PROJECT MAUI - ONCOLOGY

WARRINGAH ROAD & WAKEHURST PARKWAY, FRENCHS FOREST

SCHEDULE OF CHANGES	DEVELOPMENT APPLICATION Rev Revision Description Date
00. Change in layout and heights of	A Section 4.55 Update 23.06.202 B For Section 4.55 application 30.06.202
plant and mechanical overruns. External louvre screening updated to suit.

Maui - Healthcare Warringah Road & Wakehurst Parkway, Frenchs Forest, NSW Section 4.55 Modification

Warringah Road & Wakehurst Parkway, Frenchs Forest, NSW Section 4.55 Modification Genesis Care 11/ 41-43 Bourke Rd, Alexandria, NSW, 2015 Client (02) 8236 3300 Team 2 701/1 Chandos Street, St Leonards, NSW, 2065 (02) 9437 3166 Architect Drawing Name Drawing No. Landscape Masterplan L-101

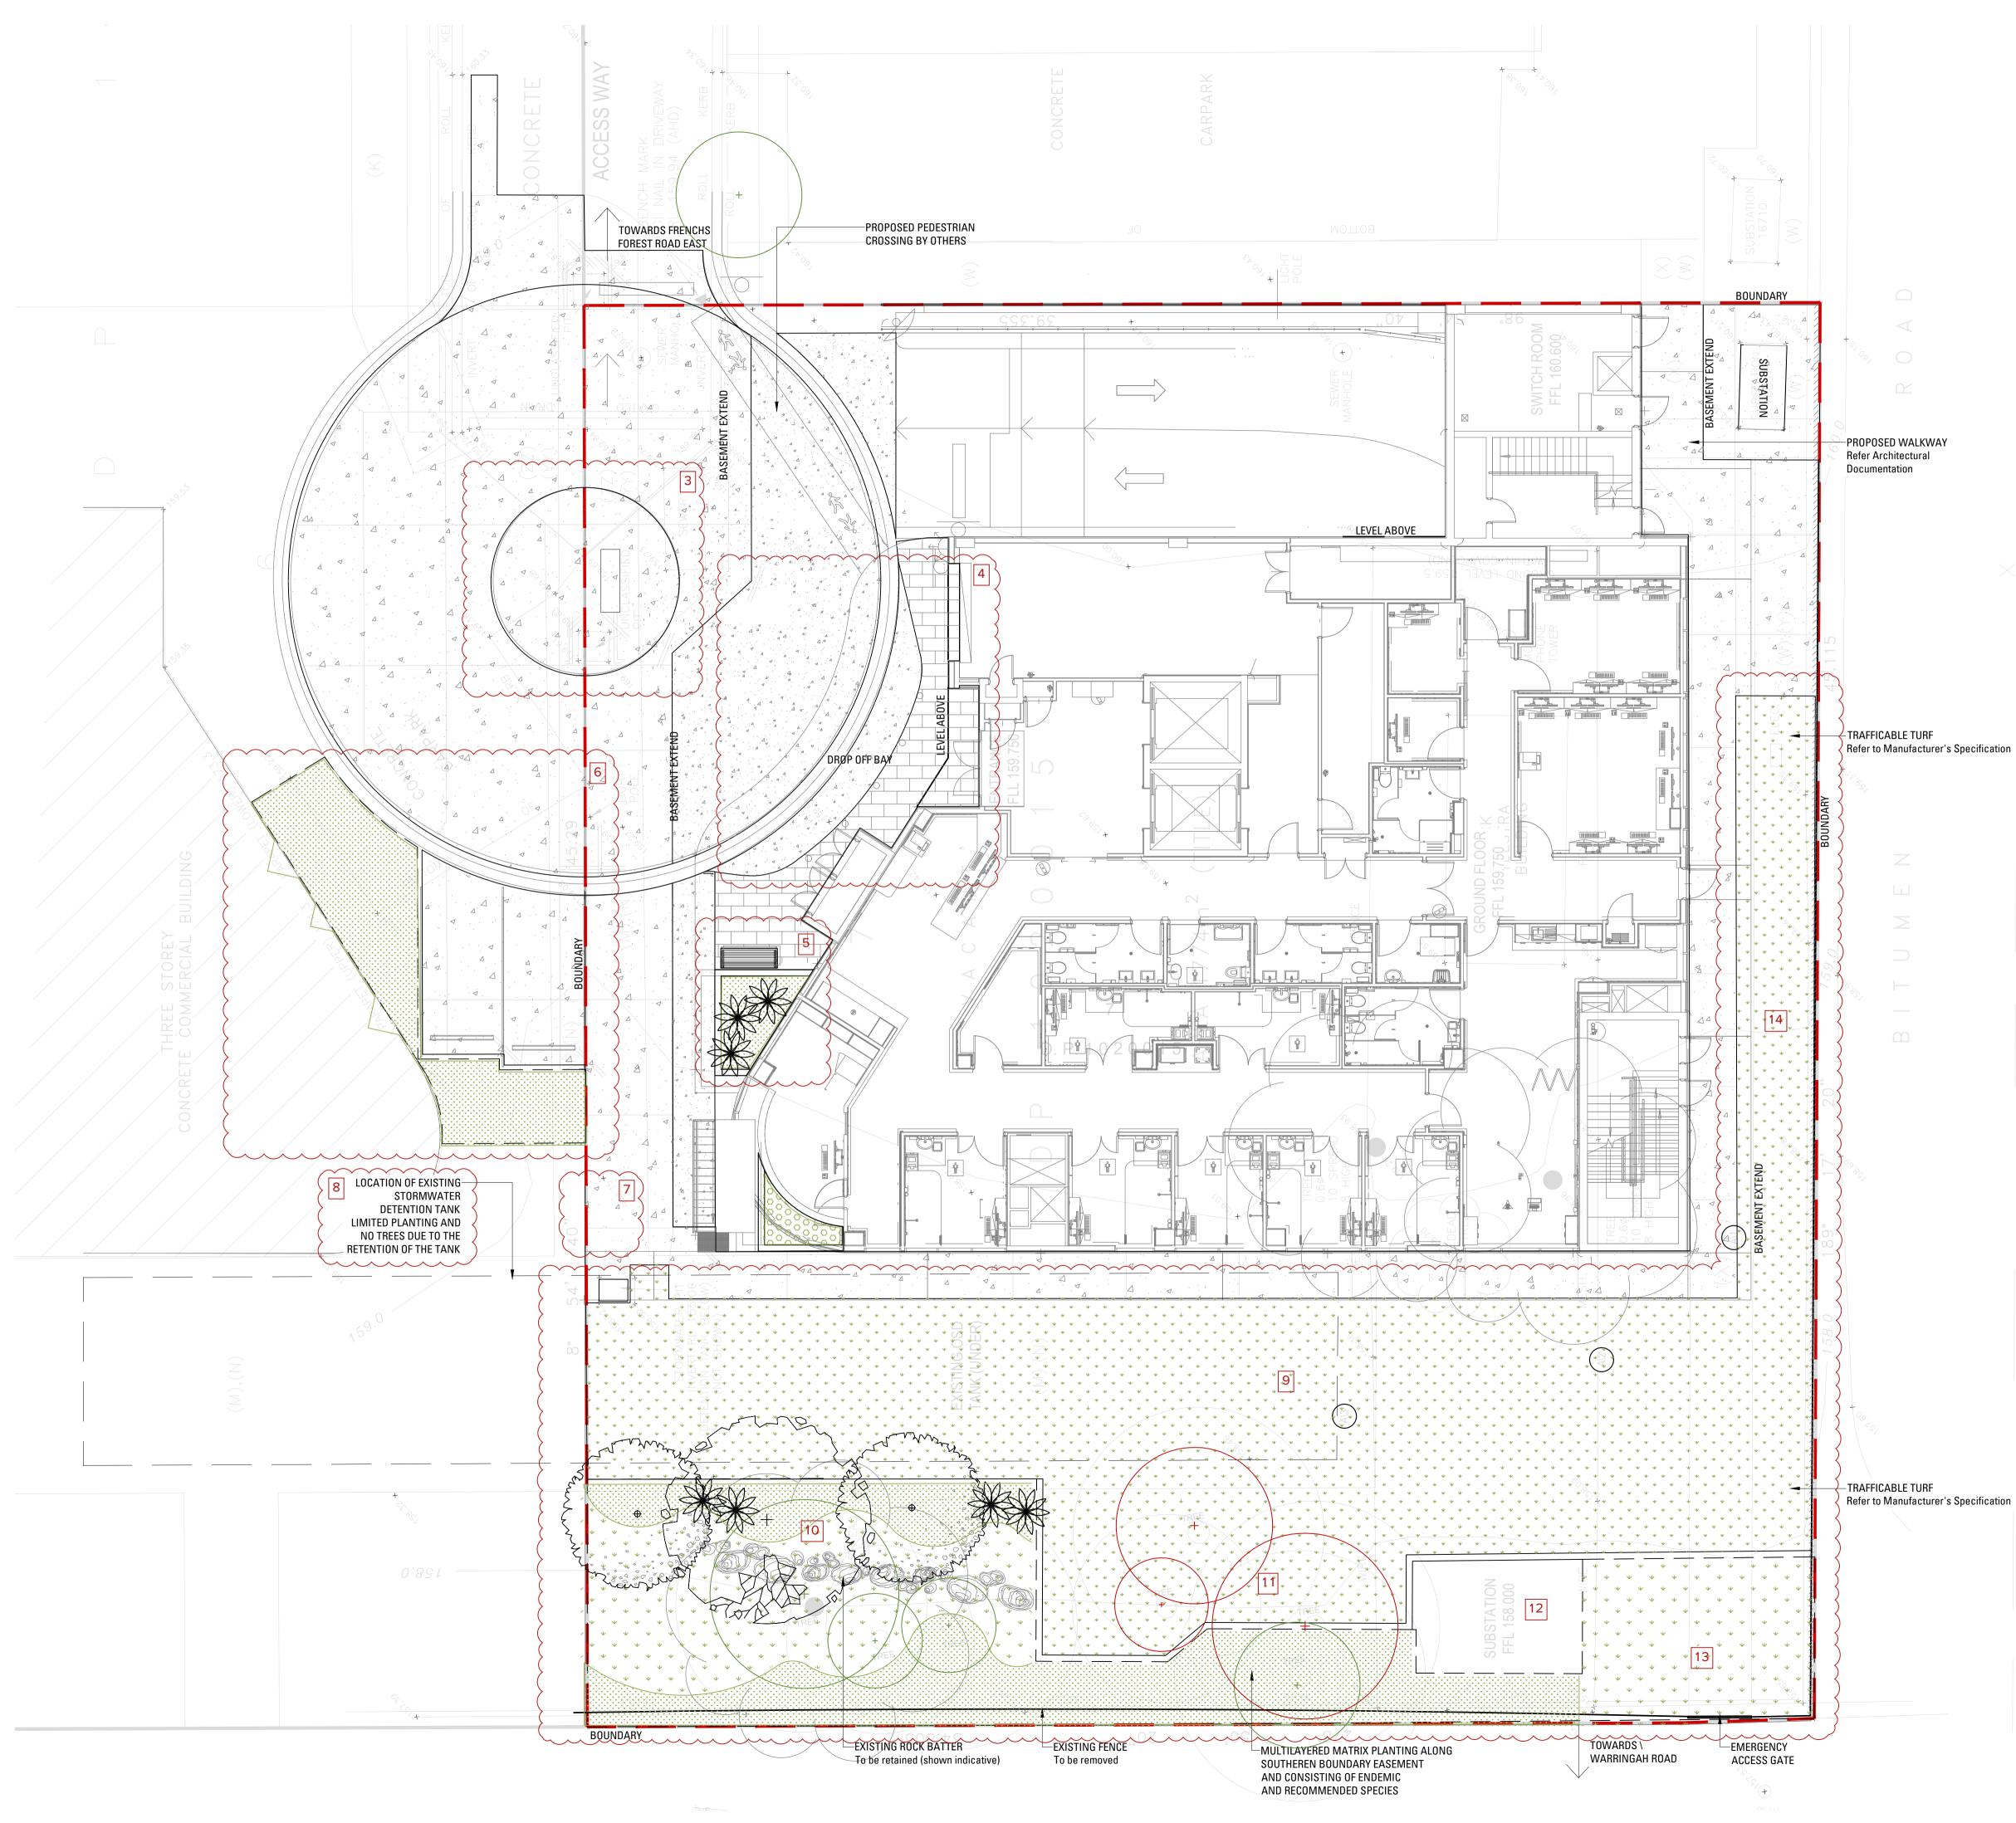
SCHEDULE OF CHANGES: 3: Planting removed to provide required access. 4: Drop-off bay revised. Layout and surface material. 5: Seating area changed to accommodate revised architectural layout. 6: Parking layout revised. Landscape treatment to edges added. 7: Path width revised to provide required access. Planting removed. 8: Correct size of OSD tank below added. 9: Planting removed and replaced with trafficable turf. 10. Tree and understory planting revised due to access constraints. 11. Existing trees to be removed due to access constraints. 12: Planting removed and substation added. 13: Emergency access added.
14: Planting removed and replaced with trafficable turf along Eastern boundary. 15: Legend updated.

Section	4.55 Modification
Client	Genesis Care 11/ 41-43 Bourke Rd, Alexandria, NSW, 2015 (02) 8236 3300
Architect	Team 2 701/1 Chandos Street, St Leonards, NSW, 2065 (02) 9437 3166
Drawing No.	Drawing Name Setout and Grading Plan

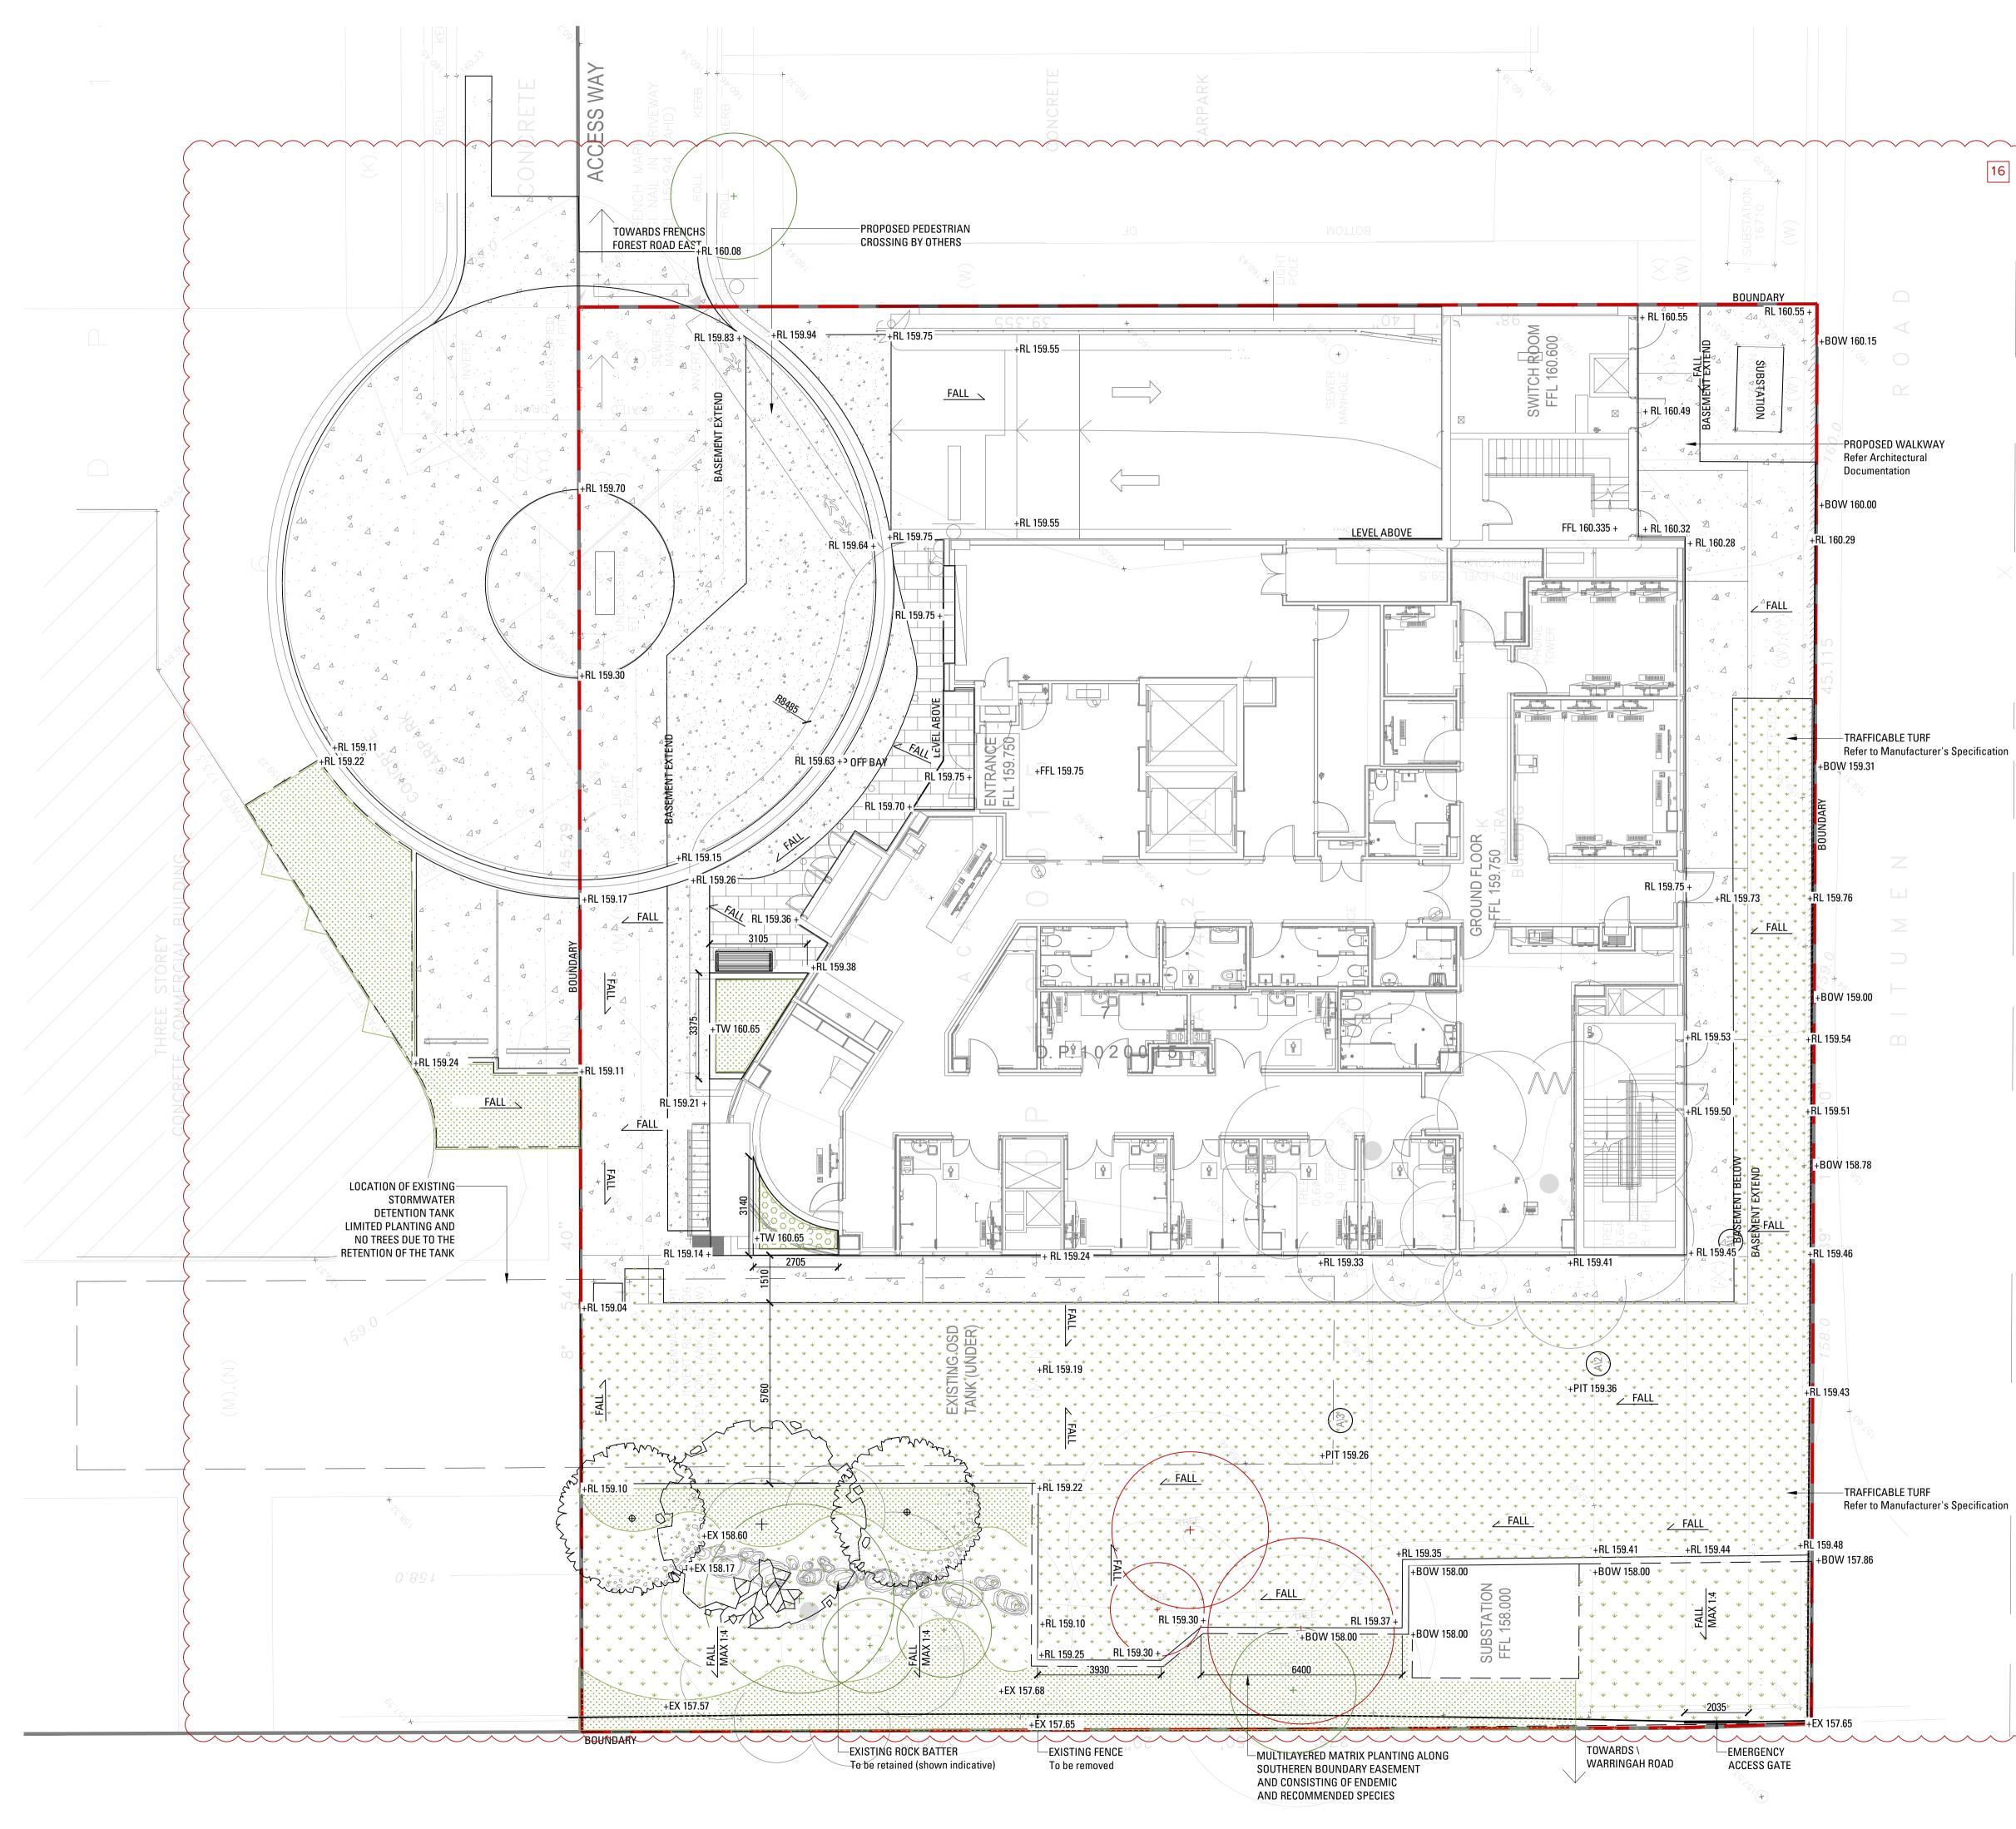
SCHEDULE OF CHANGES: 16: Levels updated to match new design and revised Civil documentation.

Client	Genesis Care 11/ 41-43 Bourke Rd, Alexandria, NSW, 2015 (02) 8236 3300
Architect	Team 2 701/1 Chandos Street, St Leonards, NSW, 2065 (02) 9437 3166
Drawing No.	Drawing Name Hardworks Plan

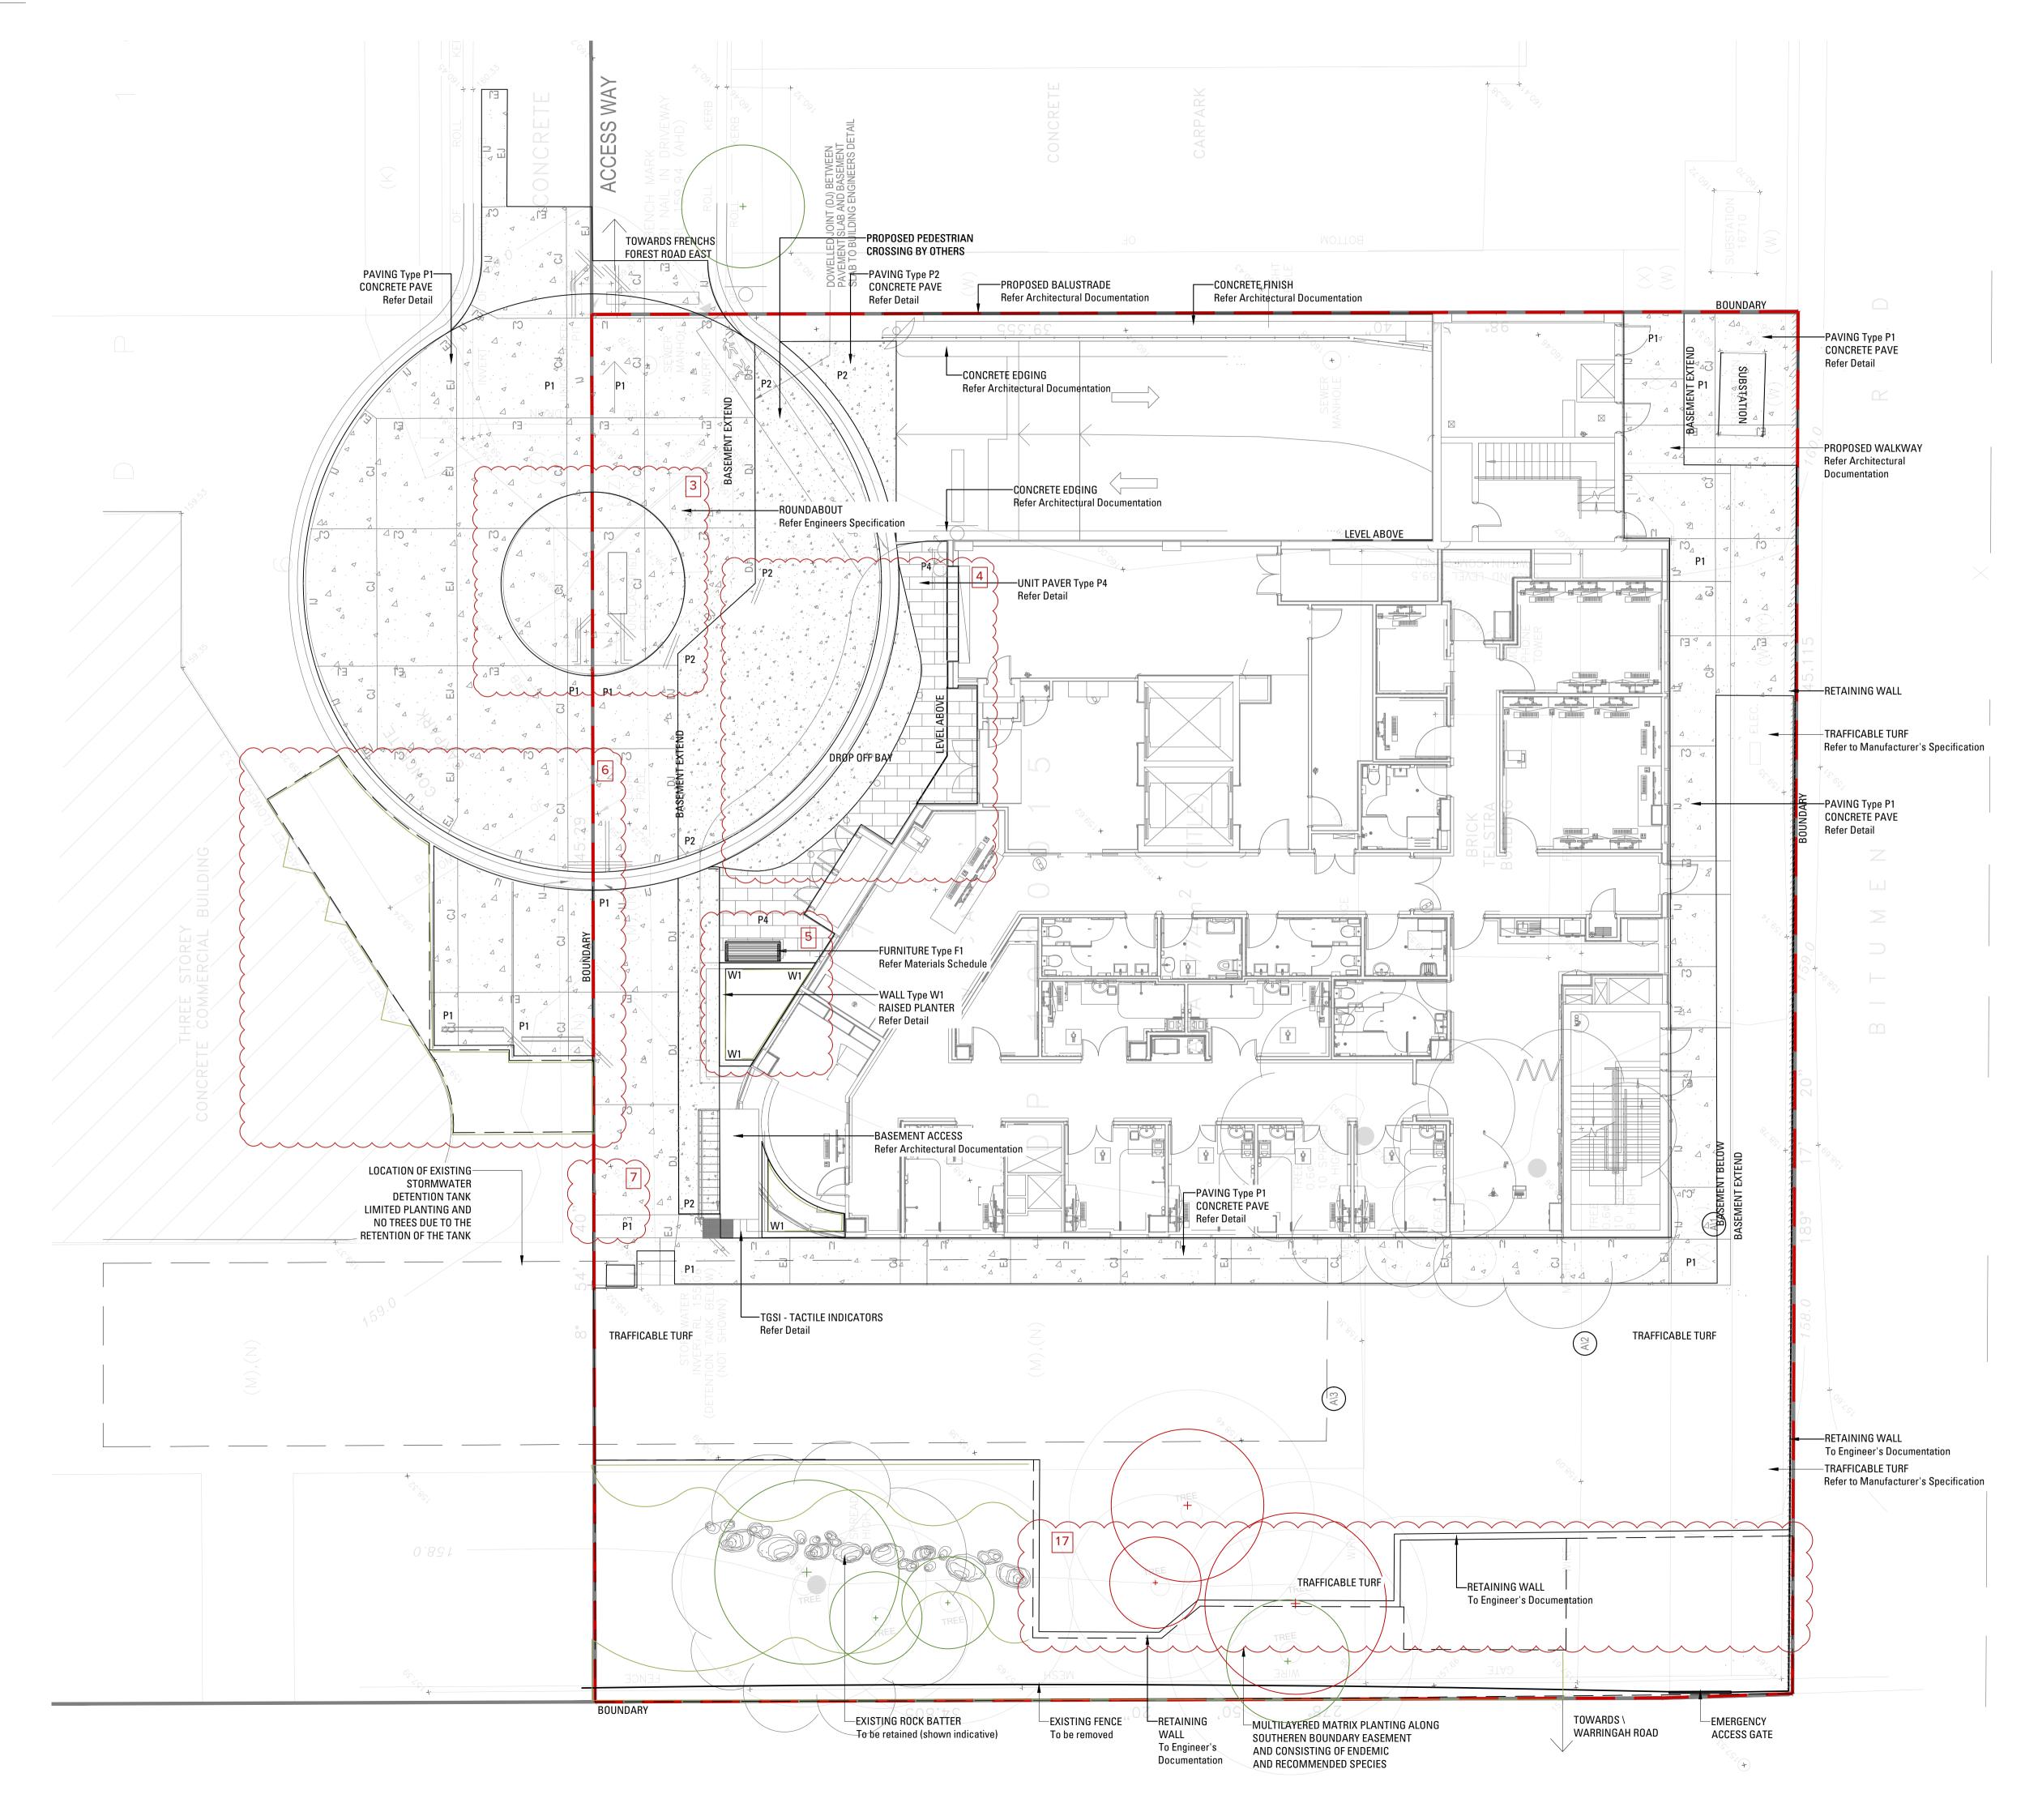
3: Planting removed to provide required access. 4: Drop-off bay revised. Layout and surface material. 5: Seating area changed to accommodate revised architectural layout. 6: Parking layout revised. Landscape treatment to edges added. 7: Path width revised to provide required access. Planting removed. 17: Retaining wall added.
